**Johnston County Public Schools  
HVAC CONTROLS REPLACEMENTS – PACKAGE 6**

**ADDENDUM NO. 2**

**DATE:** December 14, 2023

**PROJECT:** Johnston County Public Schools  
Controls Replacements – Package 6

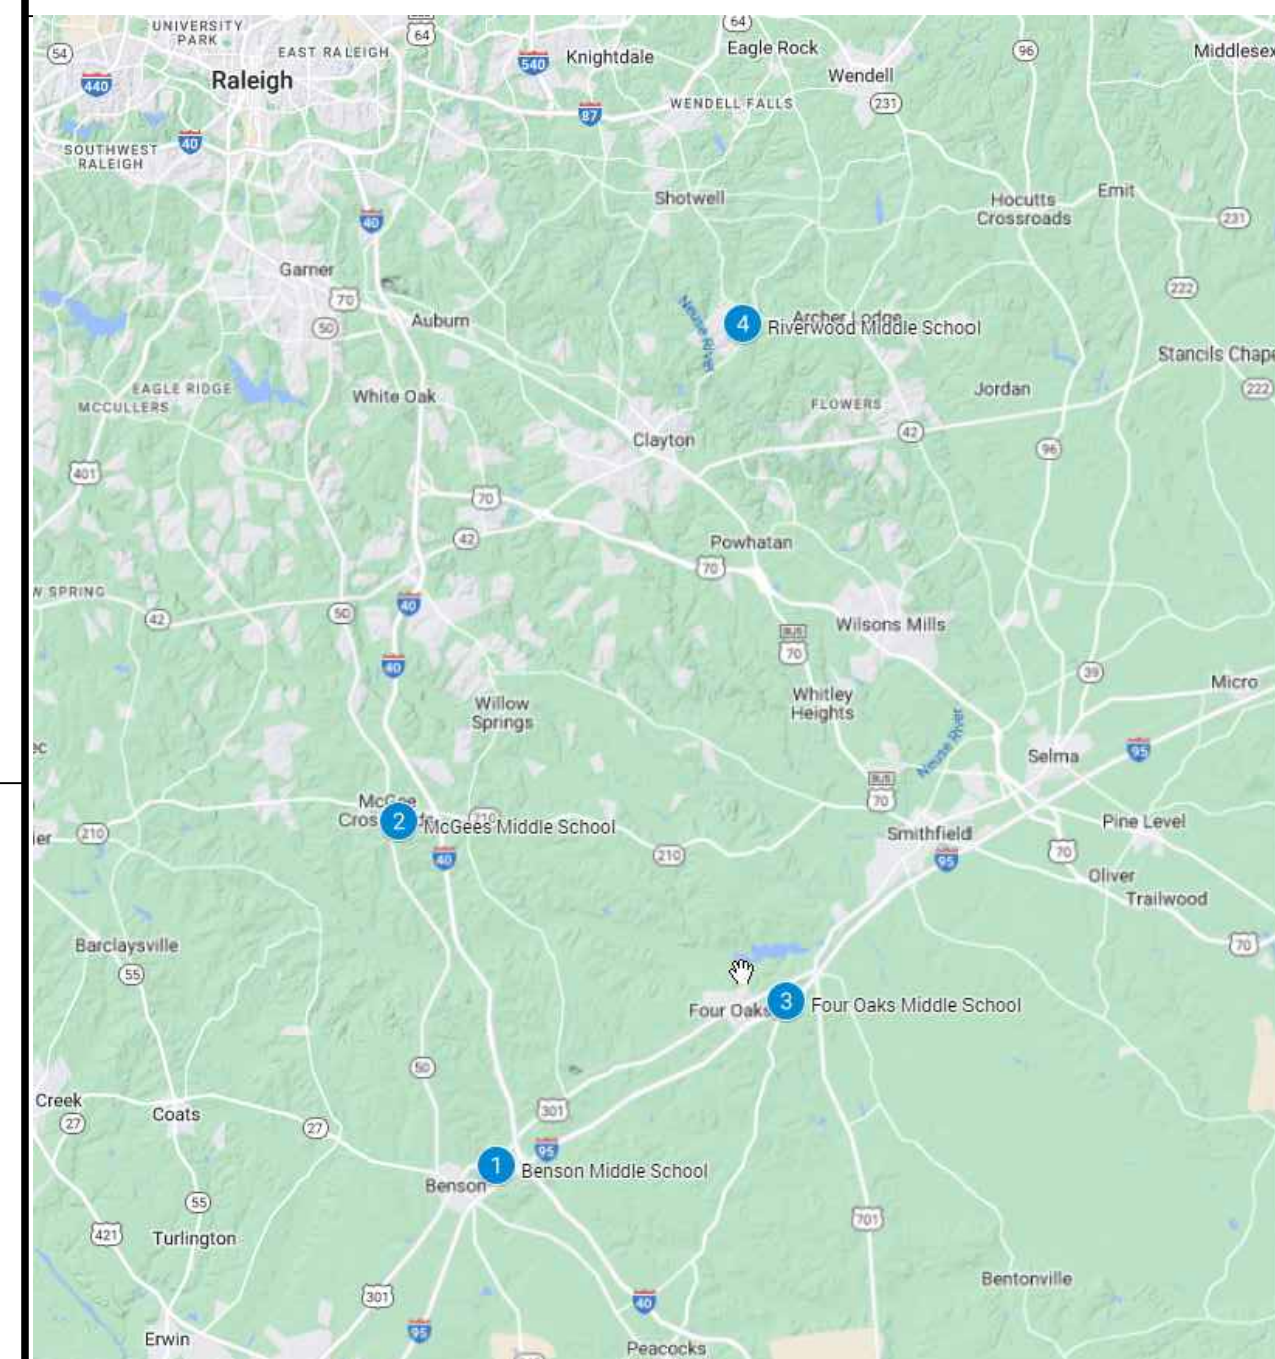
Yes
  5. Per the spec for this project all controls panels are to be UL listed panels. They are also to have hinged doors and removable back plates. Please verify that the existing control panels will not meet this spec and will need to be replaced.

Control Panel Assemblies must be UL listed. Enclosure must be listed either as an assembly “508A closed” or as a backplate with components “508A open”. If the installation includes only the controller that is UL listed in the existing control panel then the control panel is not considered an assembly and will not have to have a 3rd party listing or new control panel assembly listing. Reuse of existing control panels may be done at the contractor’s discretion to meet this requirement and take responsibility of the existing panel. The controls contractor will take responsibility and warranty for all control system components that are reused or new to complete a fully functioning control system compliant with the contract drawings and specifications.

**OM-502**  
SHEET NO. OF ##

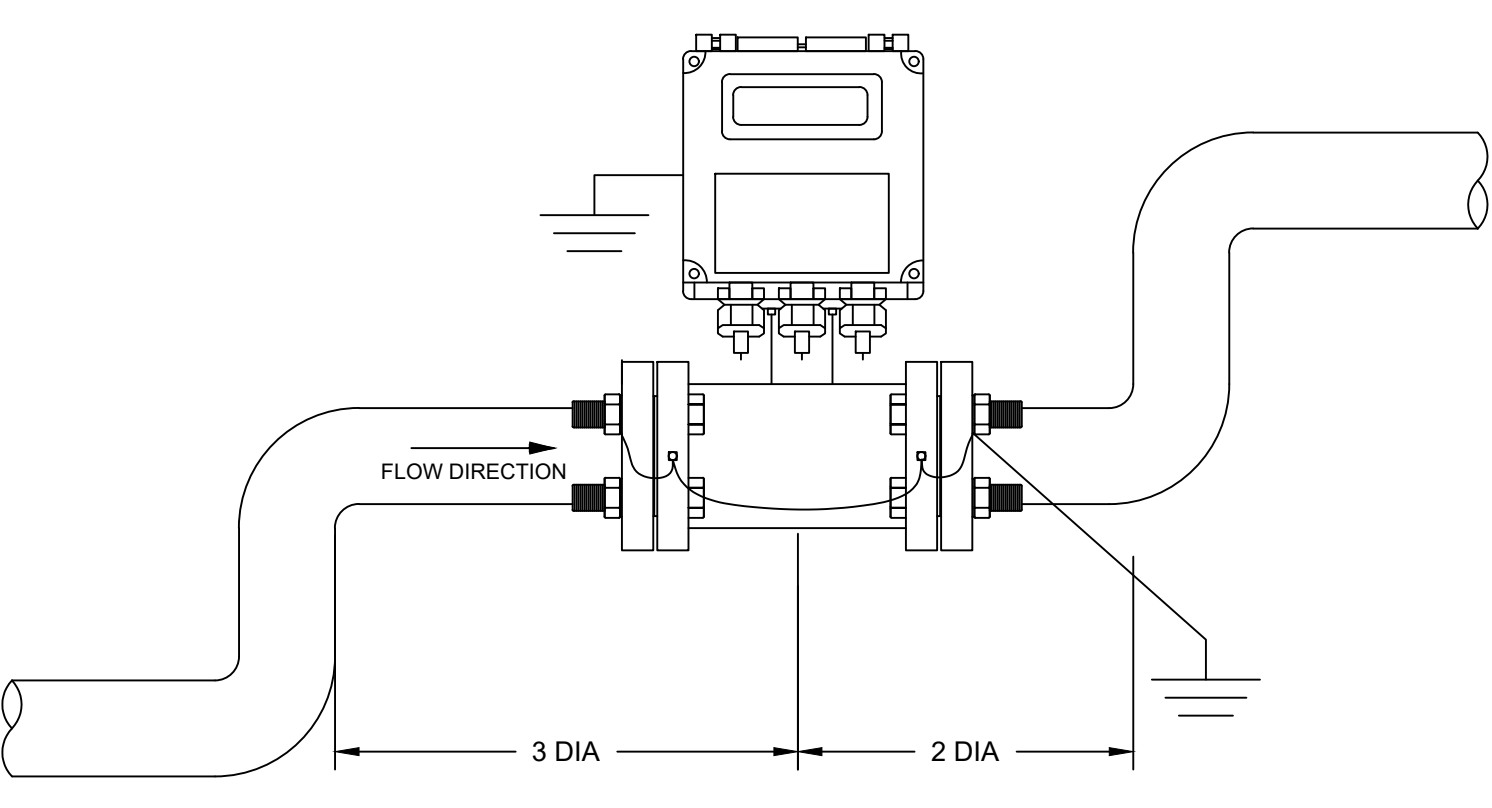
1. Sheet 0G-001 – Sheet added.
2. Sheet 0M-502 – New sheet for added details.
3. Sheet 0M-720 – Added gymnasium timer switch to SOO.
4. Sheet 0M-723 – Add CO2 to heat pump

BALANCE EXISTING MANUAL BALANCING VALVE (CIRCUIT SETTER) TO 5 GPM EACH (APPROXIMATELY 3 PER SCHOOL) TYPICALLY NEAR THE END OF EACH CLASSROOM WING. PROVIDE CHANGE ORDER TO REPLACE WITH AUTOMATIC BALANCING VALVE (FLOW LIMITER) IF EXISTING CIRCUIT SETTER IS INOPERABLE FOR APPROVAL BY ENGINEER.

INSTALL VIA MANUFACTURER'S INSTALLATION INSTRUCTIONS INCLUDING BUT NOT LIMITED TO STRAIGHT RUN AND GROUNDING REQUIREMENTS.

**TITLE**  
BENSON MS  
AREA A

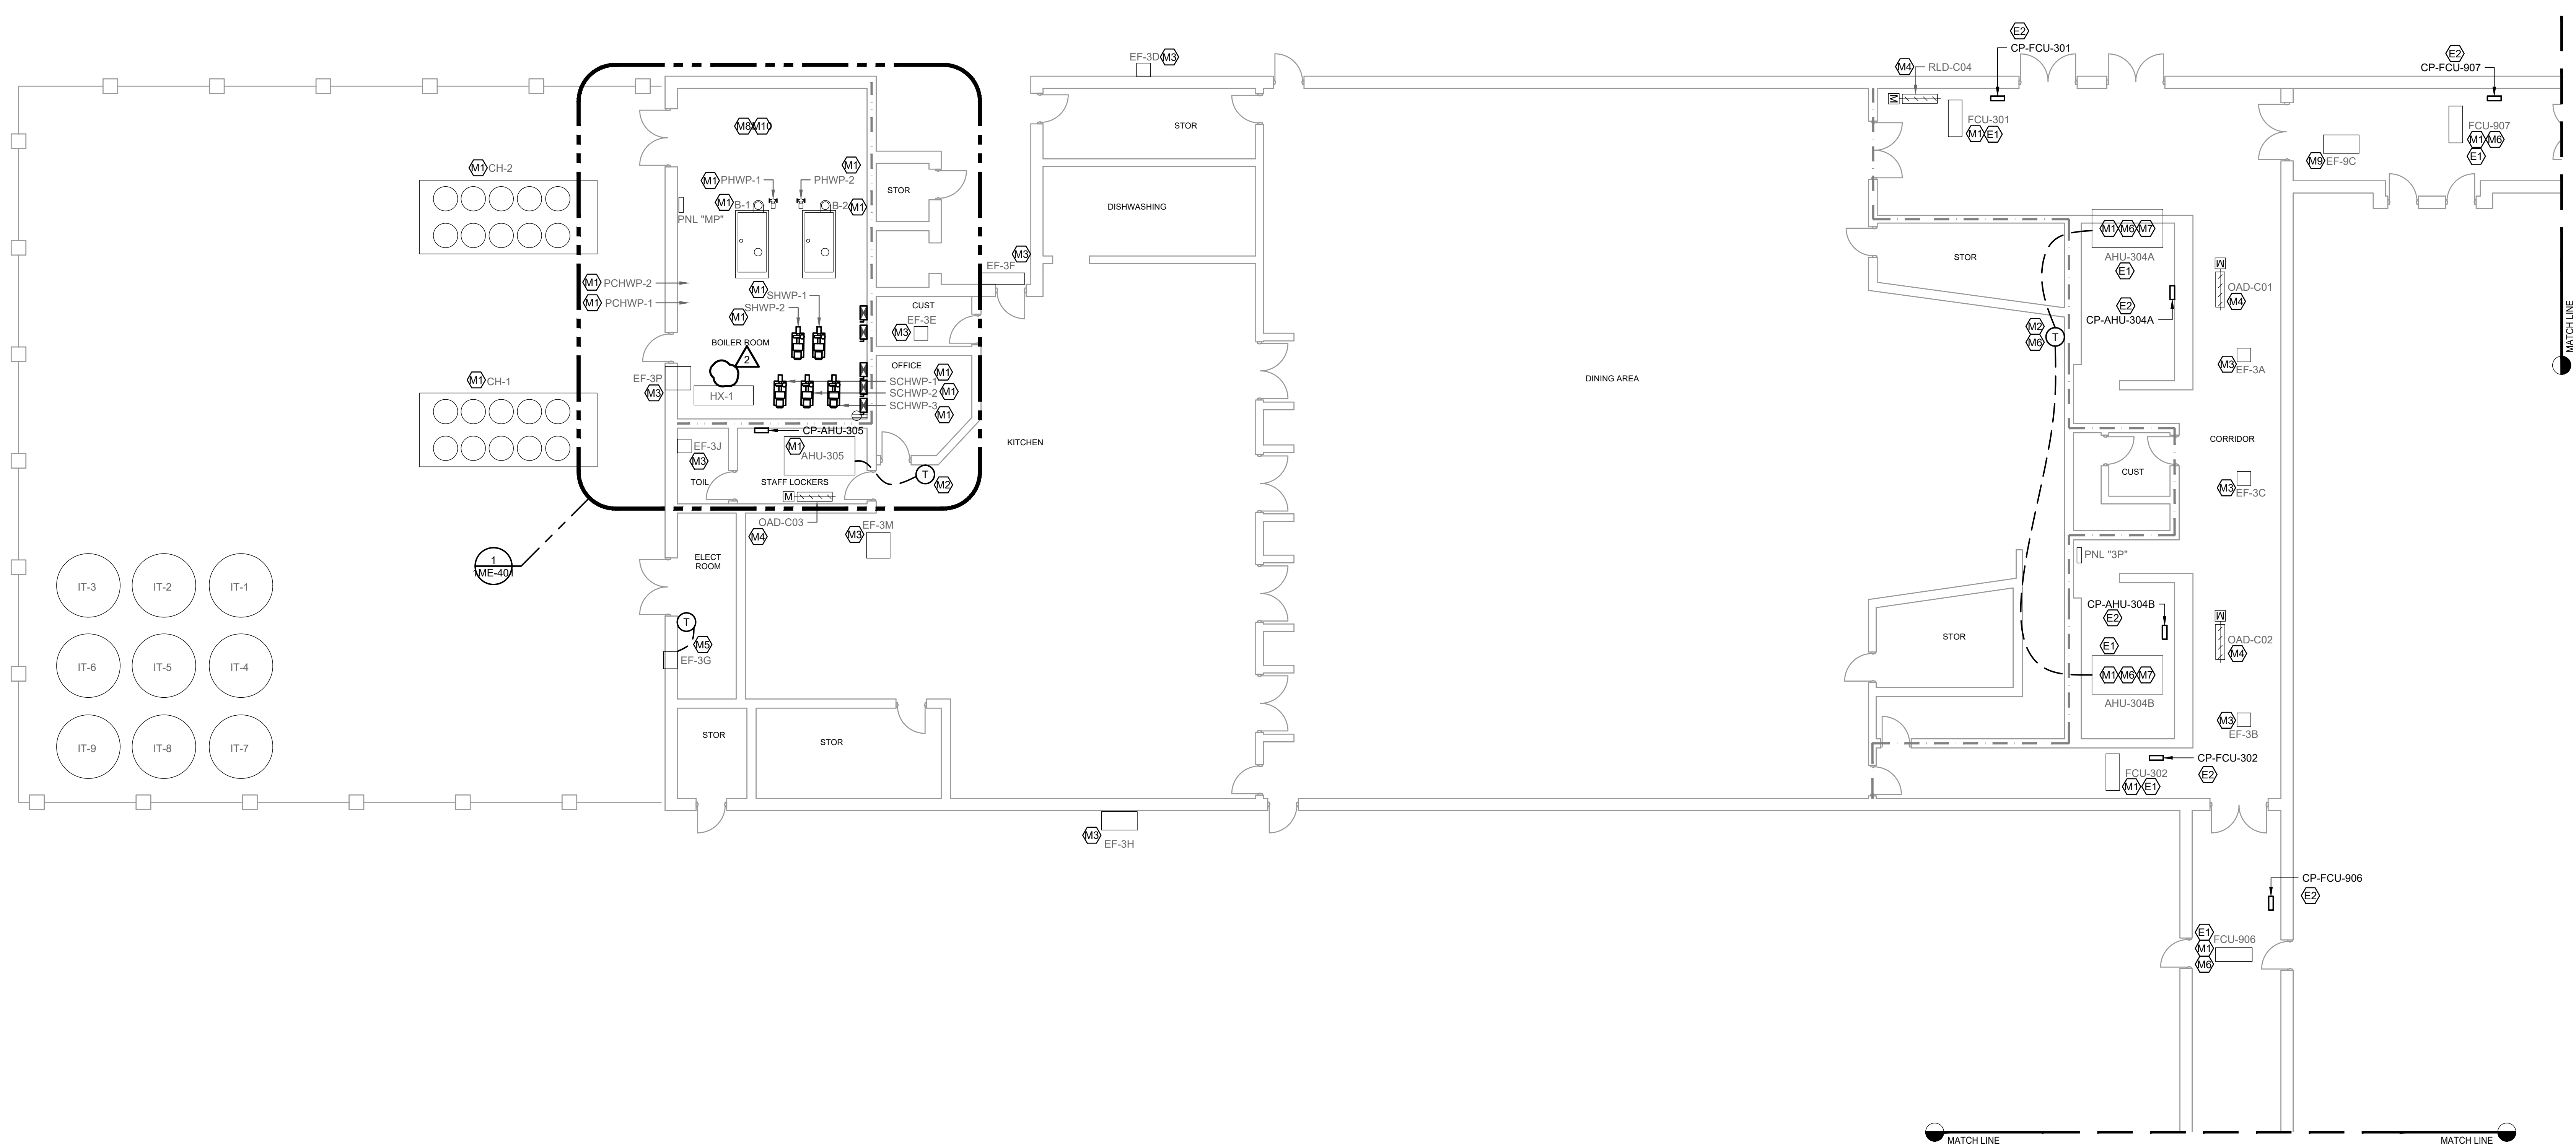
5. Sheet 1ME-201 – Keynote removed.
6. Sheet 1ME-203 – Keynote removed.
7. Sheet 1M-601 – Damper and Air System schedules adjusted.
8. Sheet 1M-602 – Flowmeter schedule adjusted.

**2ME-201**

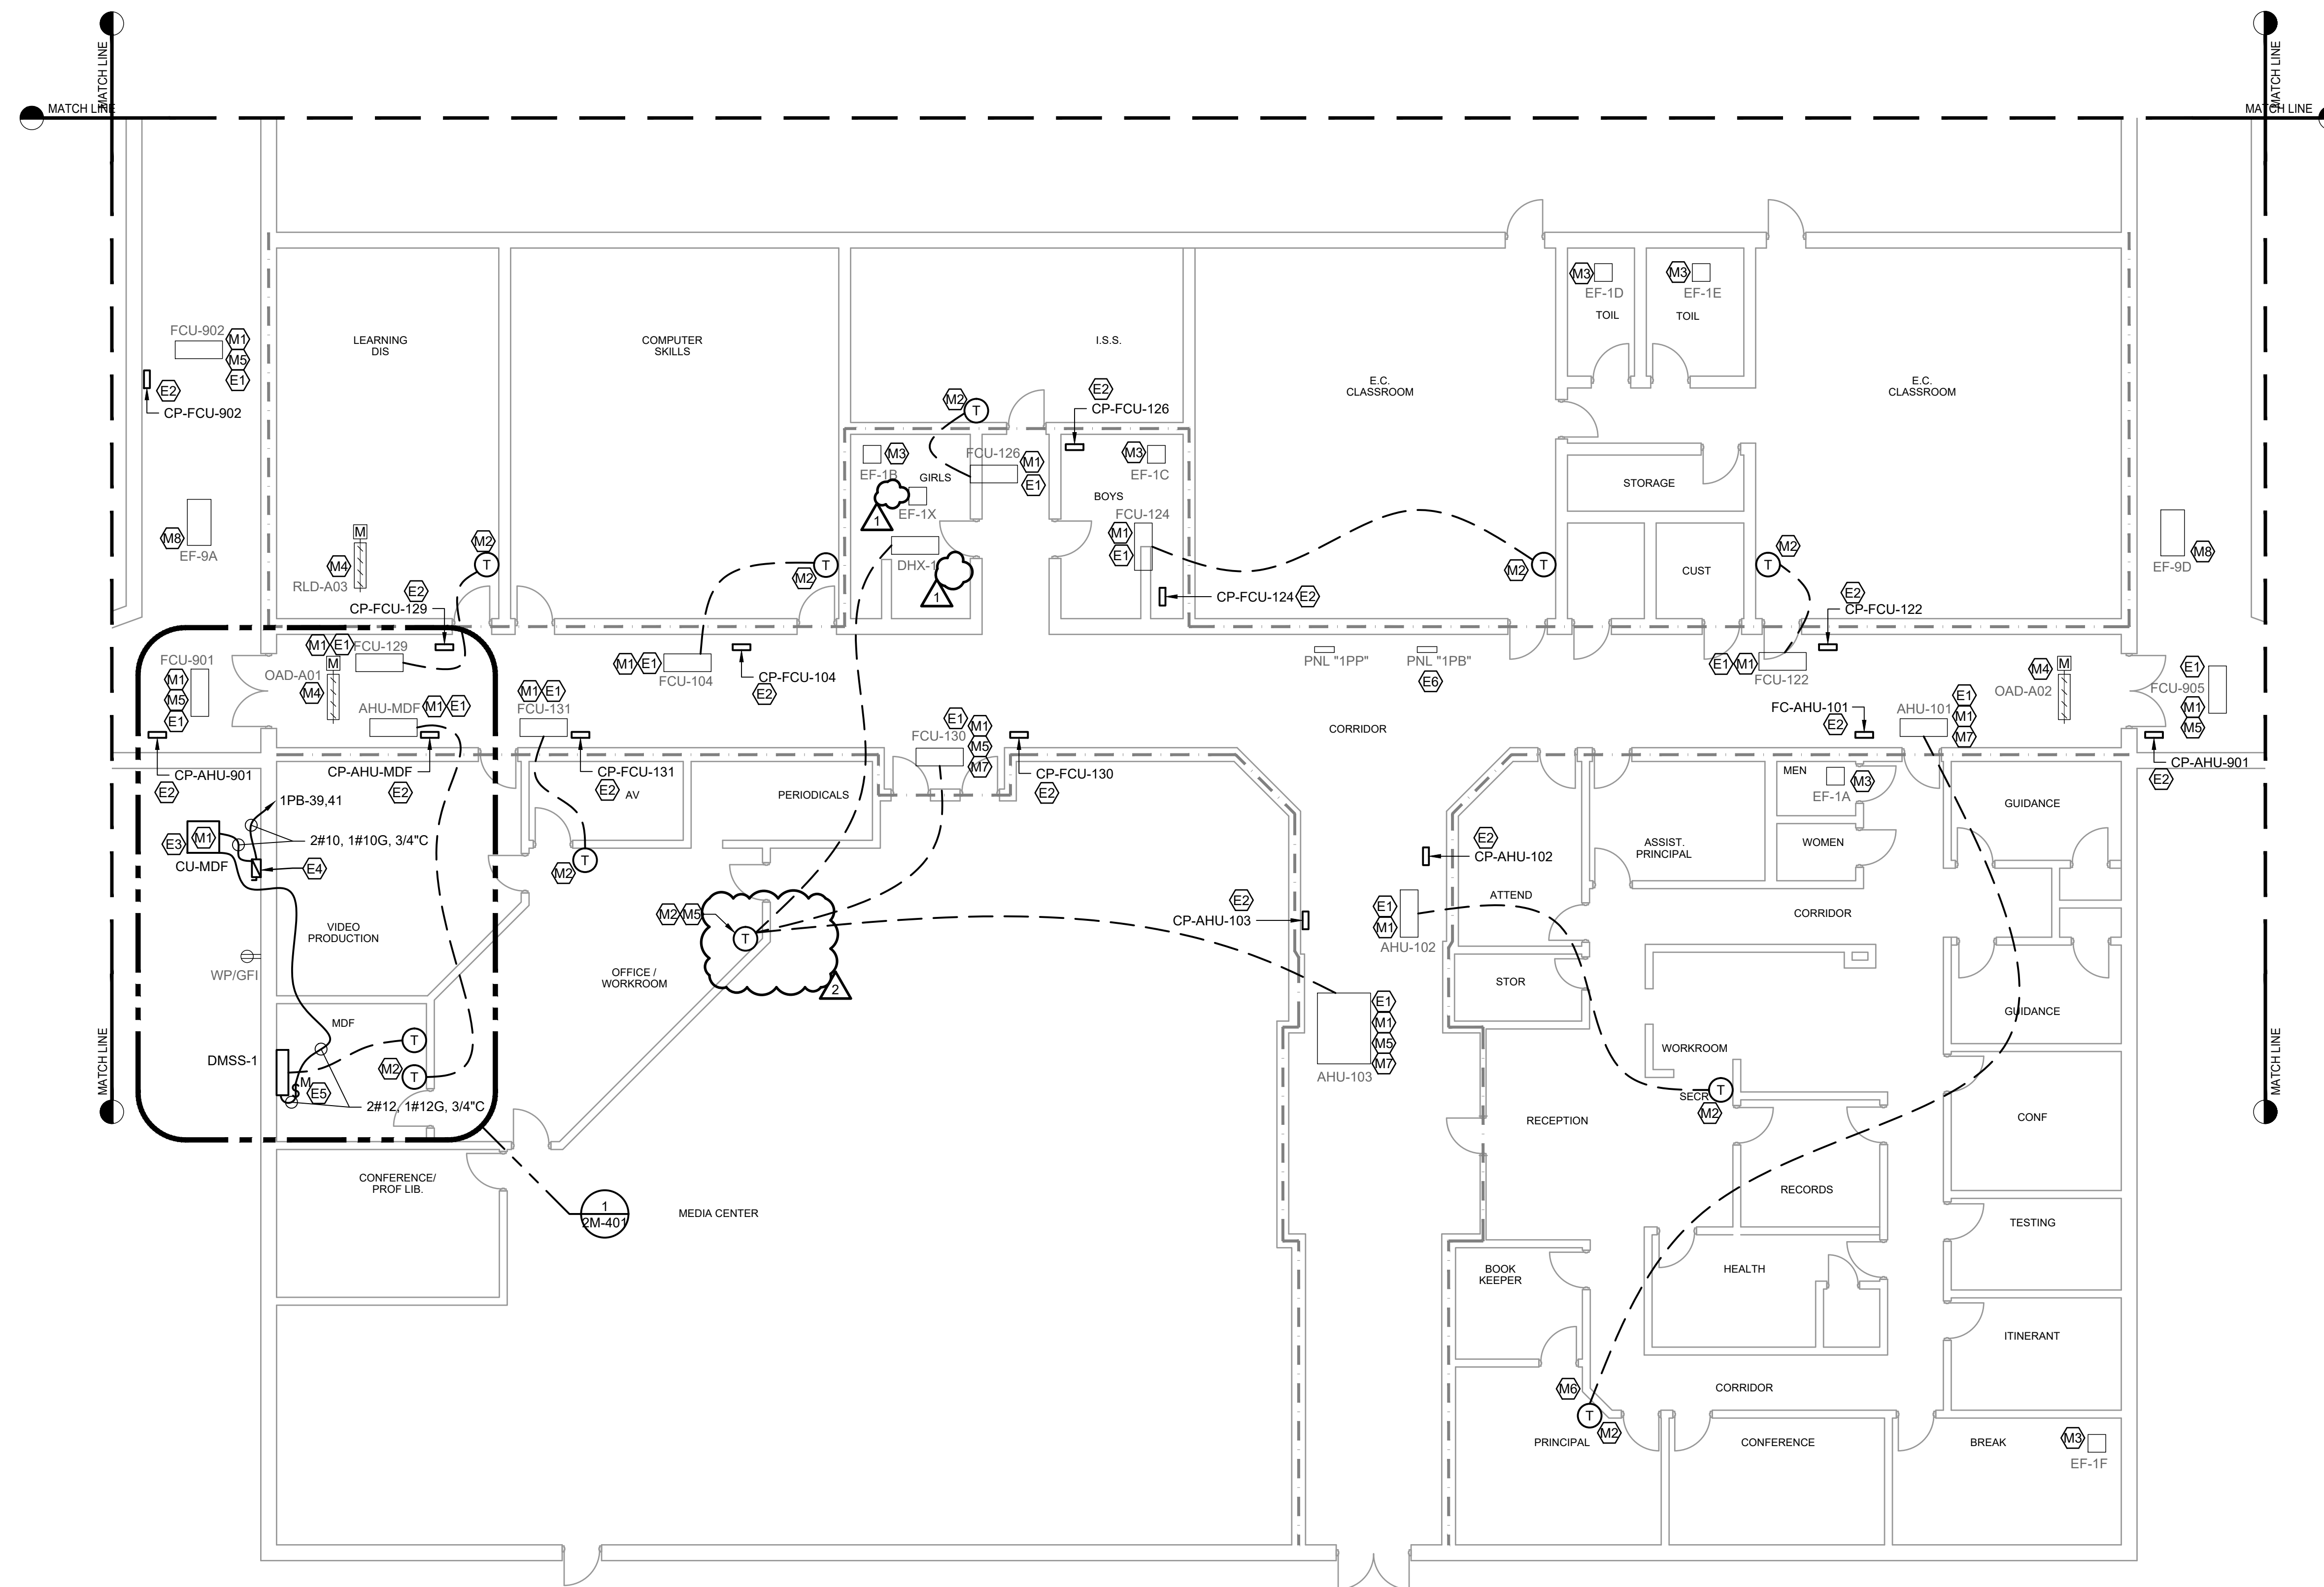
9. Sheet 2ME-201 – Keynote removed. Thermostats combined for FCU-130 and AHU-103.
10. Sheet 2ME-204 – Keynote removed.
11. Sheet 2ME-205 – Keynote removed.
